EA-12-023

Subject: FORT CALHOUN STATION – NRC SPECIAL INSPECTION REPORT
05000285/2011014; FINDING OF PRELIMINARY HIGH SAFETY
SIGNIFICANCE

Figure 1: Simplified 480 Vac Distribution Diagram

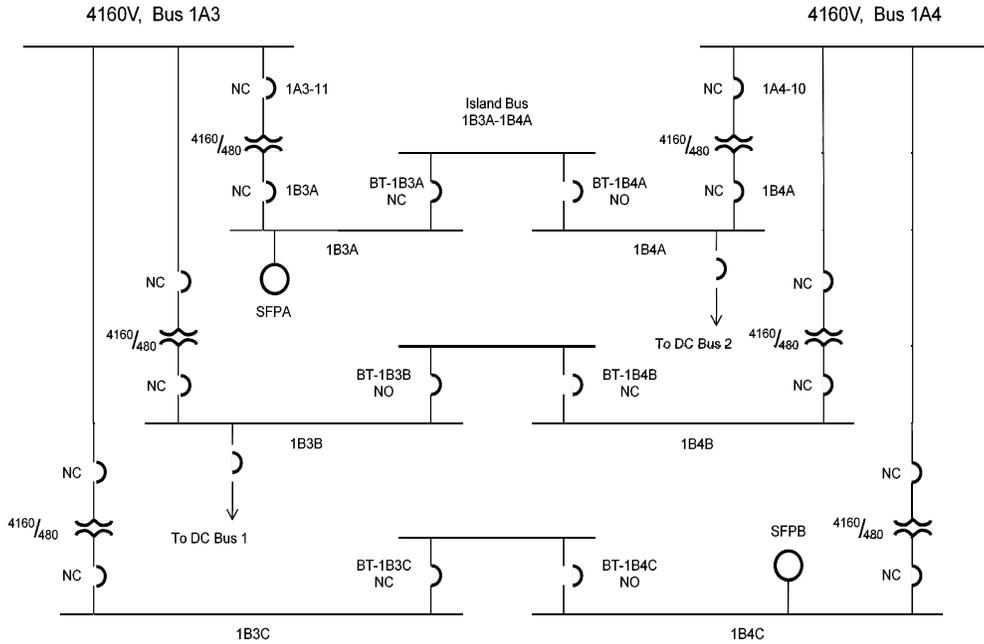
The team concluded that the licensee failed to maintain the electrical power distribution system design and licensing bases. The system was designed to provide two redundant, electrically and physically independent distribution trains of electrical power to safety-related loads during anticipated operational occurrences, design basis accidents, and external events. The design basis included provisions to limit fire damage to one train of the electrical distribution system, as described in Section 8.1.1 of the Updated Safety Analysis Report.

The safety-related 480 Vac distribution system arrangement is illustrated in Figure 1 of Attachment 4. The nine 480 Vac load centers were comprised of AKD-5 low voltage switchgear. The load centers were single-ended units with a delta-delta connected power transformer on one end providing the step down function from 4160 Vac to 480 Vac. The system consisted of six main buses and three island buses. The island bus sections were connected to one of the adjacent bus sections by a normally closed bus-tie circuit breaker. The other bus-tie breaker was kept open and electrically interlocked to prevent cross-connecting the 4160 Vac buses. Three load centers were supplied by the 1A3 bus; three load centers were supplied by the 1A4 bus.

Figure 2: Simplified 125 Vdc Distribution Diagram

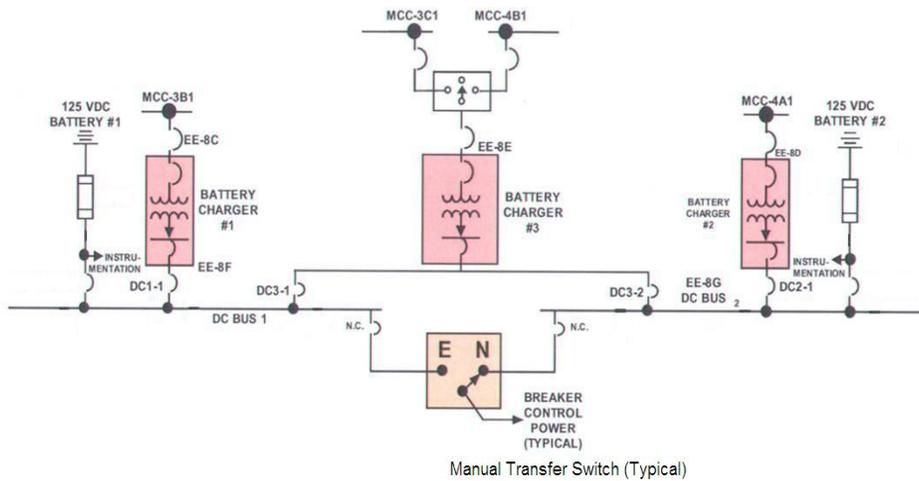
The ungrounded 125 Vdc distribution system, illustrated in Figure 2 of Attachment 4, consisted of three battery chargers, two storage batteries, two main distribution panels, manual transfer switches and other distribution equipment necessary for operation of the plant. The dc control power for each 4160 Vac and 480 Vac load center was fed via manual transfer switches, which allowed manual selection of either dc train as the source of control power to the buses. The manual transfer switches were designed with both trains of dc power in a common enclosure, with the normal and emergency supplies to the manual transfer switches fed from their respective dc buses via independent circuit breakers that were designed to provide selective fault protection and train separation.

During the event, ground alarms were received in the control room for both dc buses due to extensive damage inside load center 1B4A. Battery charger #2 was de-energized, and battery charger #3 had to be manually aligned to power dc bus #2. The team questioned the cause for the grounds, what affect the grounds had on the operability of the dc system, and what separation criteria the design was required to meet.
